## **6 Reference**

### **6.1 Technical Notes of Meeting with ERA**

## Study for Route Selection in Debre Markos under the Project for Rehabilitation of Trunk Road, Phase IV

# The Project for Rehabilitation of Trunk Road, Phase IV

**Fig.-1 Outline of Each Alternative**

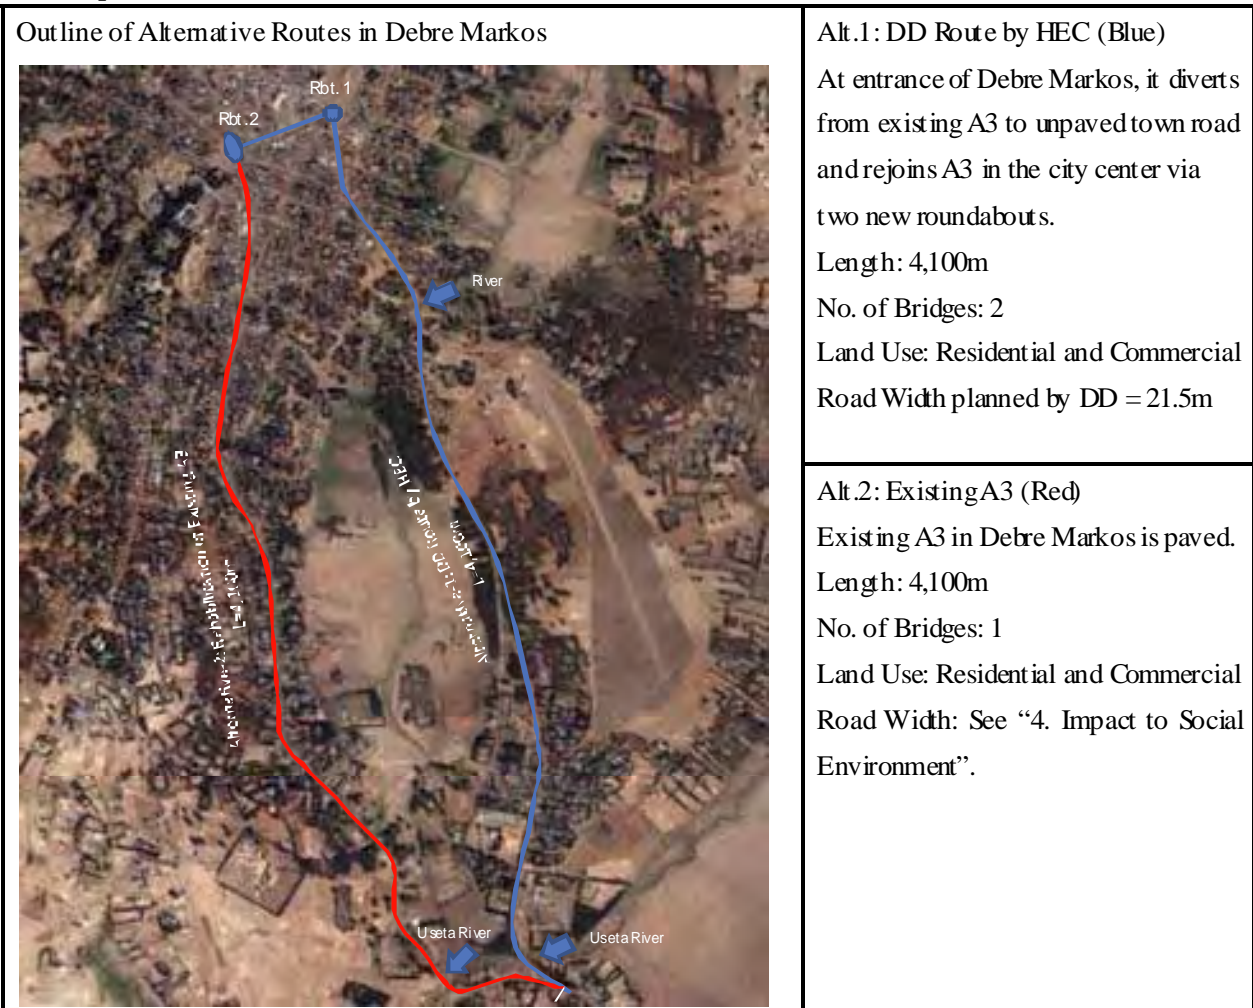
Table-1 shows that rehabilitation of existing A3 (Alt.2) is more superior than HEC (Alt.1) in all items of technical aspect.

The JICA Study Team recommends that the existing A3 route in Debre Markos should be rehabilitated under the Project for Rehabilitation of Trunk Road, Phase IV taking into account the following;

Fig.-3 Issues of Connecting Point to existing A3

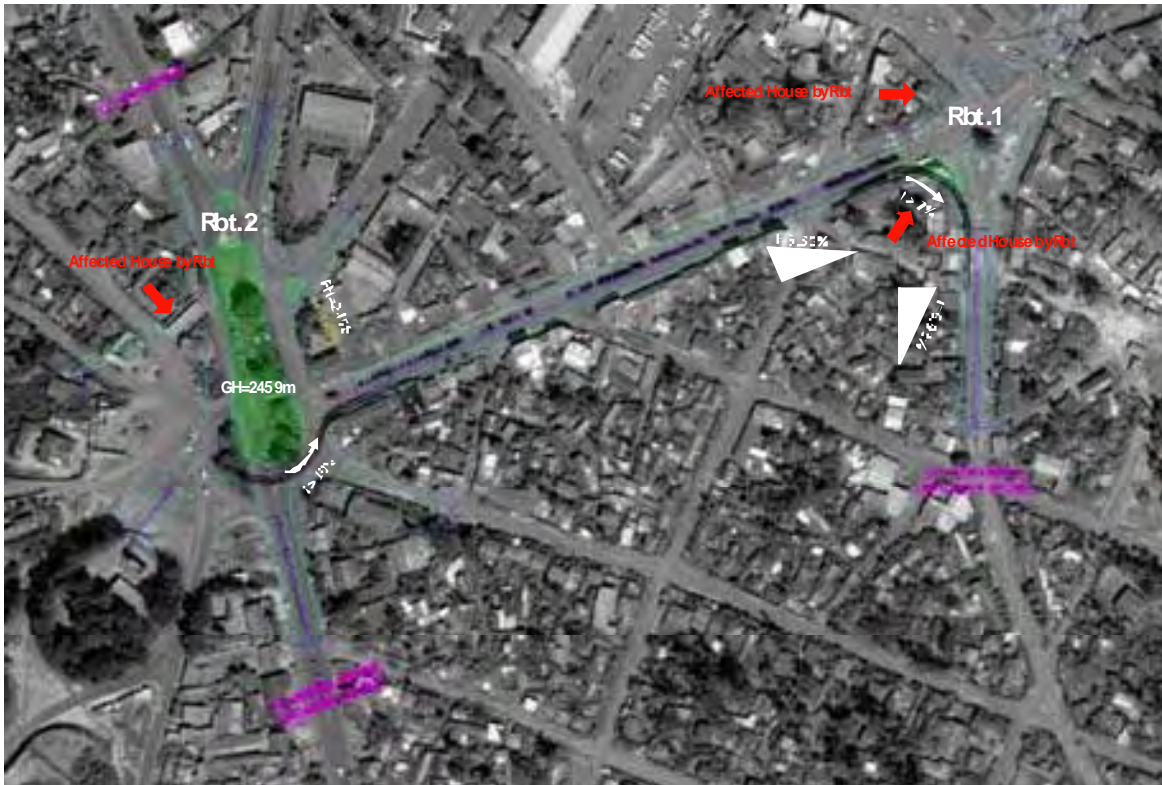
As mentioned earlier, the DD route by HEC passes two new roundabouts located within a congested town area before connecting to the existing A3. However, the elevation difference of A3 and DD route at connecting point at Rbt.2 is approximately 3m. This will result in a steep grade of more than 10% at Rbt.2 and more than 7% at Rbt.1. Consequently, these poor geometric features will constrain heavy trucks that commonly use this route. In addition, unexpected affected houses will likely be increased with the construction of roundabouts.

Figure-1 Proposed Typical Cross Section (D/Markos Town Center Section)

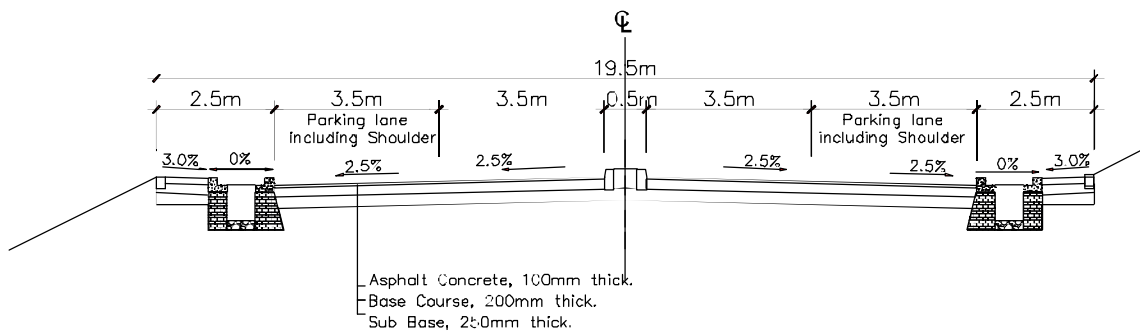
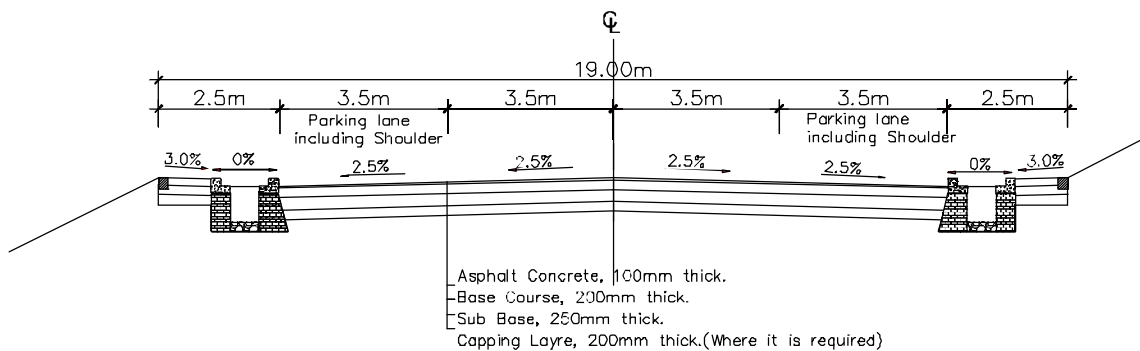
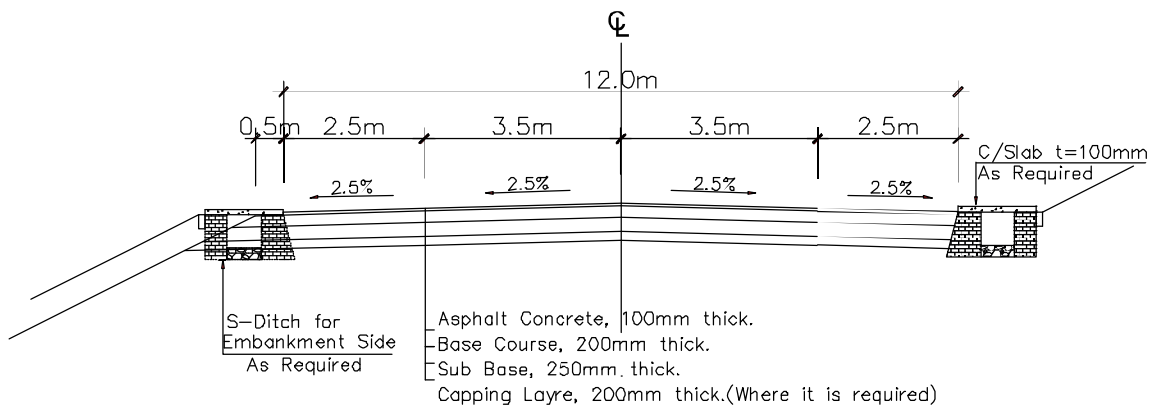
The Study Team will recommend the following typical cross sections based on the field survey and design review. Main changes are as follows:

- ✓ Reduction of median strip: 2.5m to 0.5m
- ✓ Installation of unpaved protection shoulder: 0.5m

Figure-3 Countermeasure Concepts Proposed by the Study Team

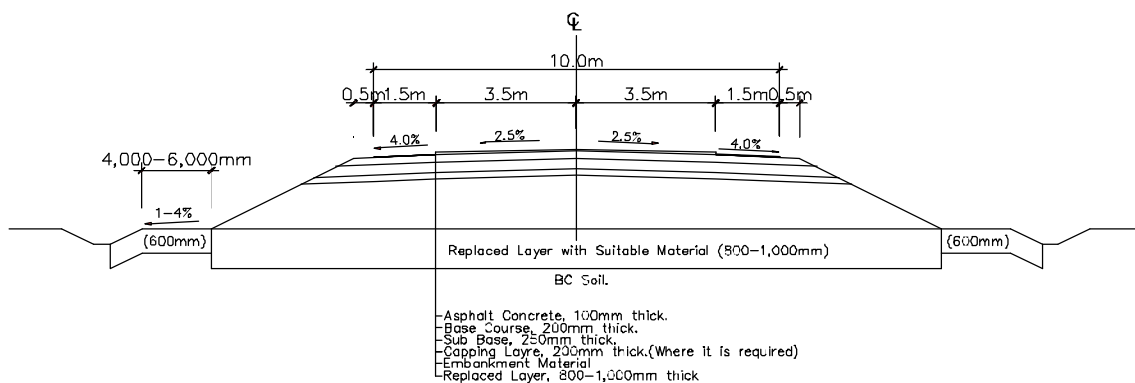
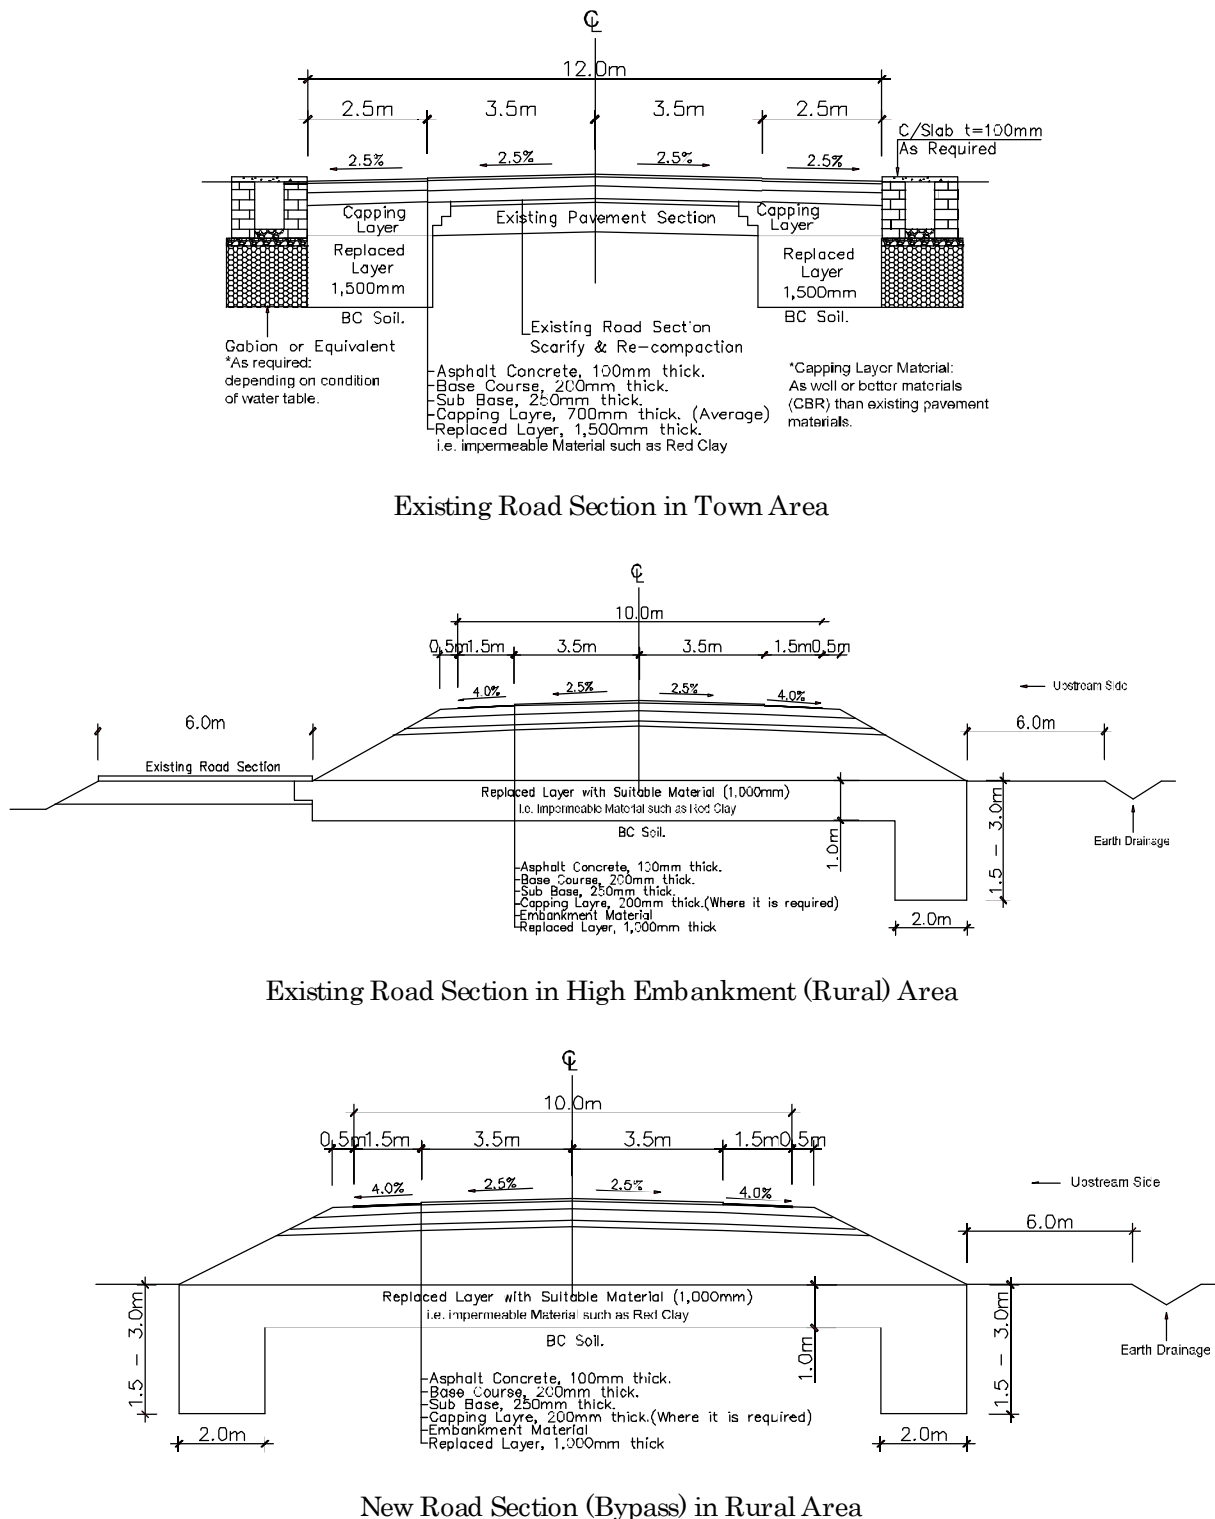
Regarding countermeasure for expansive (black cotton) soils, our proposal was agreed by your side but only in principle with some comments. Your comments were that the Consultant should incorporate a filter membrane (such as geo-textile sheet) and an impermeable membrane on the outer and inner face of the buried gabion, respectively. The inclusion of such membranes and protection method for gabion bed will be decided at a later stage after confirming matters such as highest ground water table, etc, and determining whether or not buried gabions will be applied. At the moment, the concept is to have the image of the probable features of road cross section in town areas. Moreover, your side recommended that a provision for side drains be indicated on the typical cross sections on the existing road section in high embankment and new road section in rural areas.

In response to your comments, we have duly modified our proposal for typical cross sections to be adopted in cases where black cotton soils are predominant. Please see the attached document titled "Countermeasure for expansive soil on the Trunk Road A3 between Dejen and Debre Markos"

Figure-1 Comparative Illustration at Chemoga

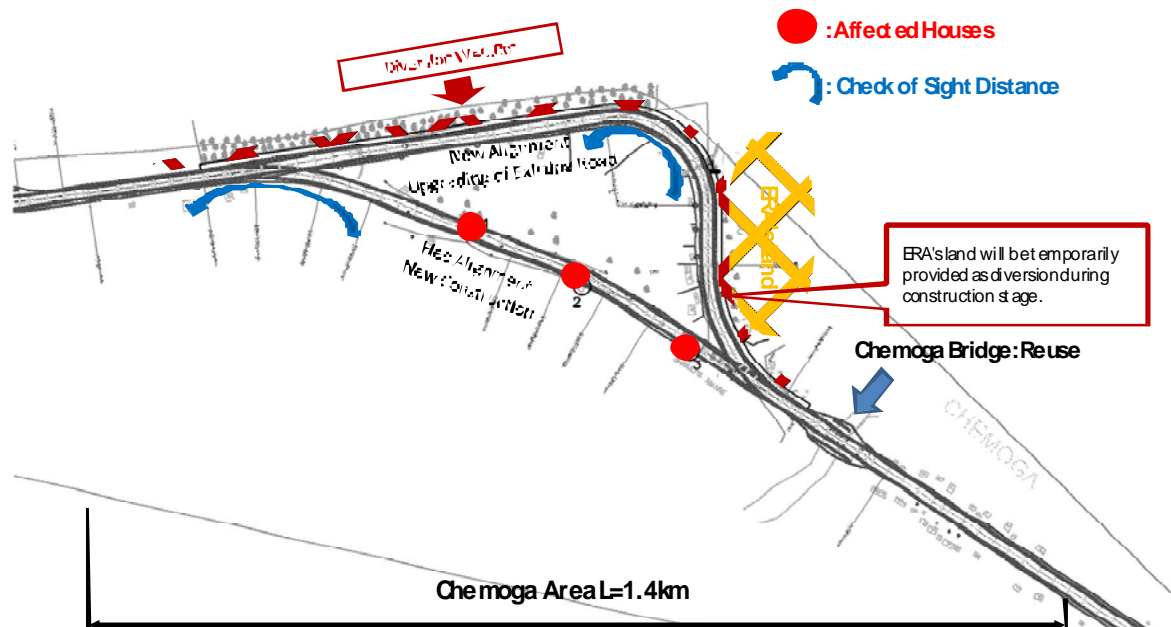
Our explanation aims at resolving the issues of Road Alignment at Chemoga (Sta. 58+000 ~ 58+700) and Applicable cross sections in Debre Markos Town (Sta. 60+800 ~ 65+400), including road width and median width.

Table-5 Recommendation of cross sections and in Debre Markos

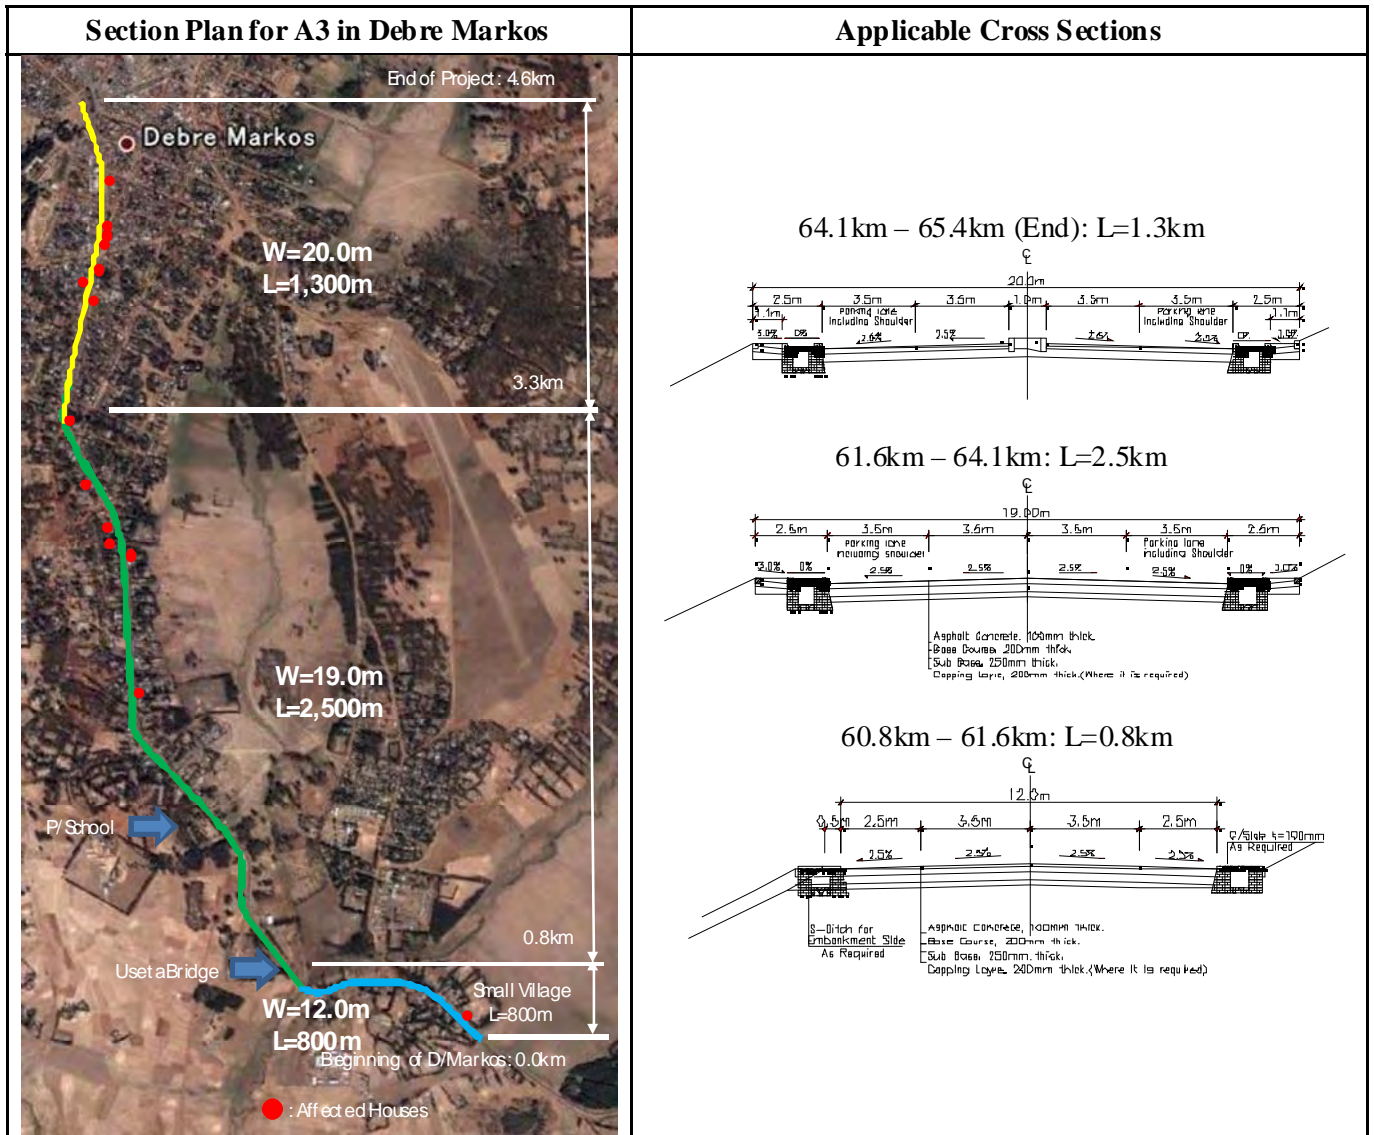
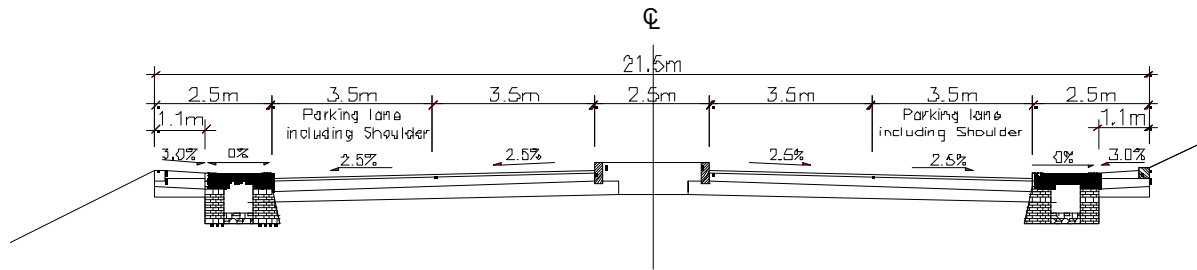
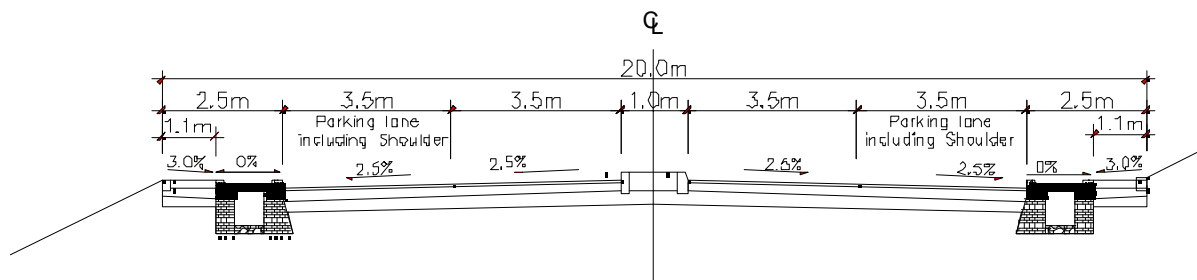
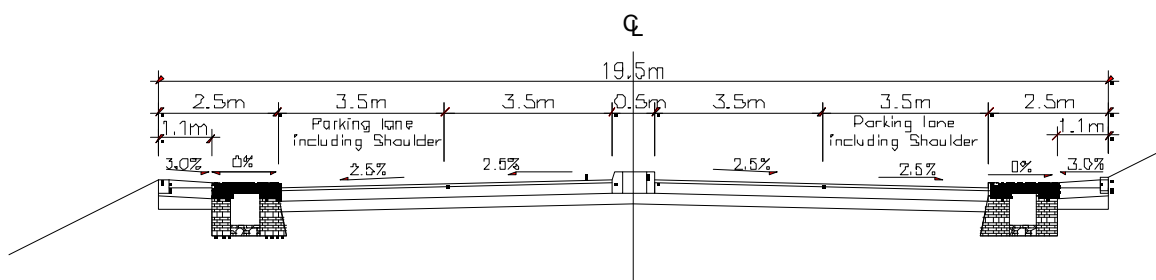
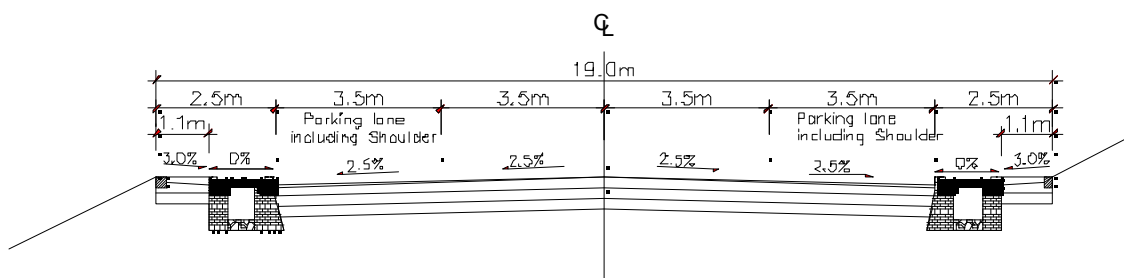
Of issues listed above, considerable expansion area of the city in the immediate future will be up to Wiseta River. For these reasons, following cross sections are

recommended to be applied in Debre Markos (refer Table-5)

**Cross section of Debre Markos Town**

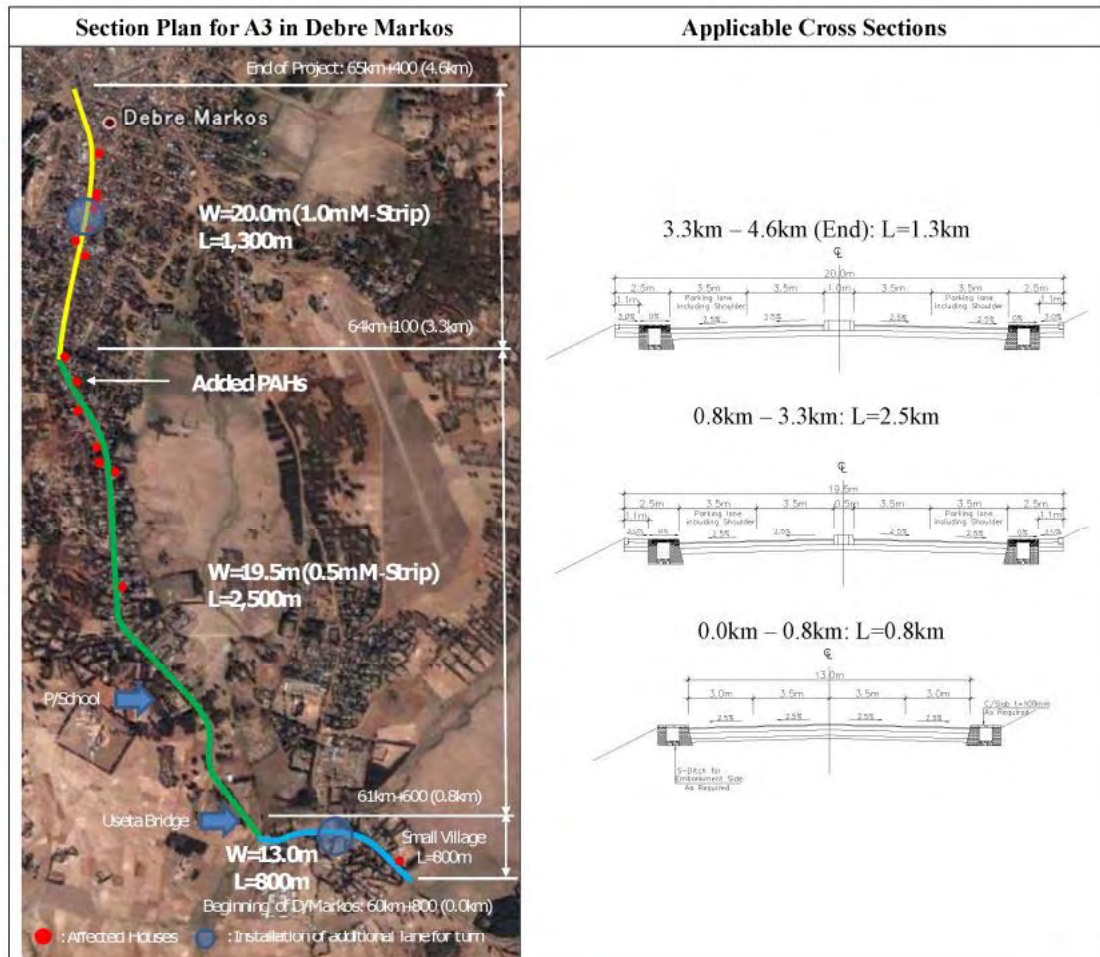
- In most cases, there is a problem of proper design of junctions and vehicular crossings at town sections. Hence, please be advised to include detail junctions and vehicular crossings in the town sections.

- ◆ Section 1 (3.3 – 4.6km, 64km+100 – 65km+400, L=1.3km) ; W=20m with median strip 1.0m
  - ◆ Section 2 (0.8 – 3.3km, 61km+600 – 64km+100, L=2.5km) ; W=19.5m with median strip 0.5m
  - ◆ Section 3 (0.0 – 0.8km, 60km+800 – 61km+600, L=0.8km) ; W=13.0m with parking lane 3.0m
- Please refer to the attached figure.

3. A left-turn lane will be incorporated at the intersection 61km+300 & 64km+750 for vehicular crossing at town sections, and the concept plan will be drawn in the report prepared in March.
